Chevron USA INC  
 Brunson ARGO  
 5812 #28

**ADMINISTRATIVE APPLICATION CHECKLIST**

Request for Administrative Approval of  
Unorthodox Oil Well Location

**Brunson Argo #28**  
1310' FNL & 970' FEL, NW/4 NW/4 of  
Section 10, T22S, R37E, Unit Letter H  
Lea County, New Mexico

## WELL LOCATION AND ACREAGE DEDICATION PLAT

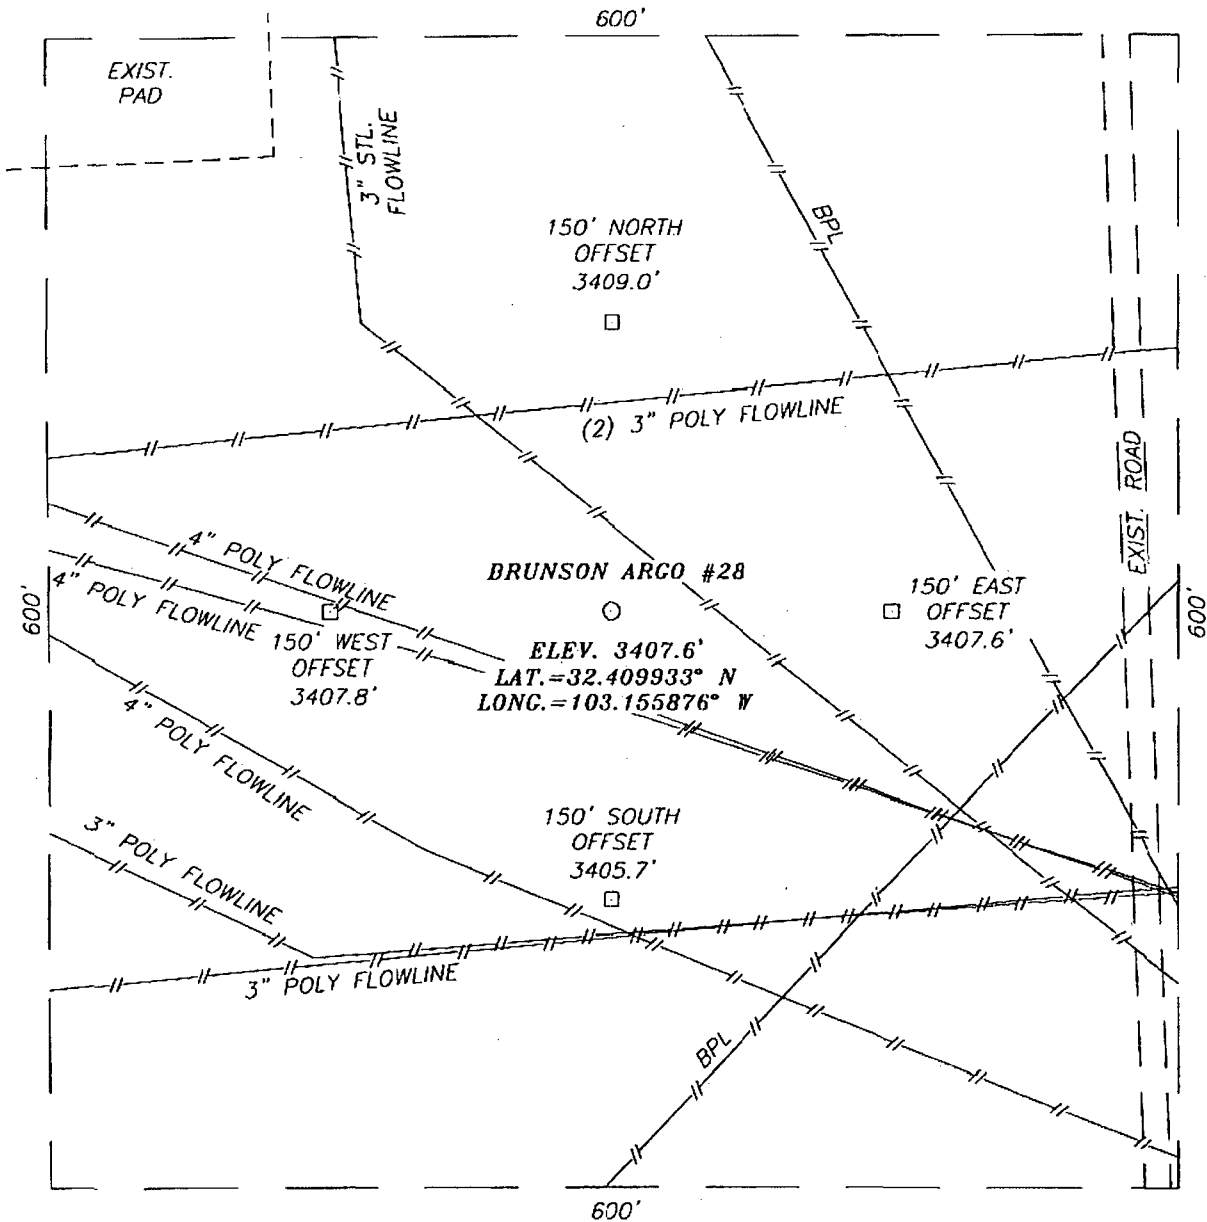
Separately, I note that the application states the proposed locations as 1310 FNL and 970 FEL of 10-22S-37E. However, the attached plats show the location at 1310 FNL and 970 FWL. All of the information in the application

(except the one statement of the location) is consistent with the location being 970 FWL. Accordingly, I assume that the 970 FEL is a typo.

Separately, I note that the application states the proposed locations as 1310 FNL and 970 FEL of 10-22S-37E. However, the attached plats show the location at 1310 FNL and 970 FWL. All of the information in the application (except the one statement of the location) is consistent with the location being 970 FWL. Accordingly, I assume that the 970 FEL is a typo.

My sincerest apologies for the oversights in the Brunson Argo #28 NSL application. Firstly, I can confirm that the correct footage call is 970 FWL, making the '970 FEL' a typo. Thanks for catching this error.
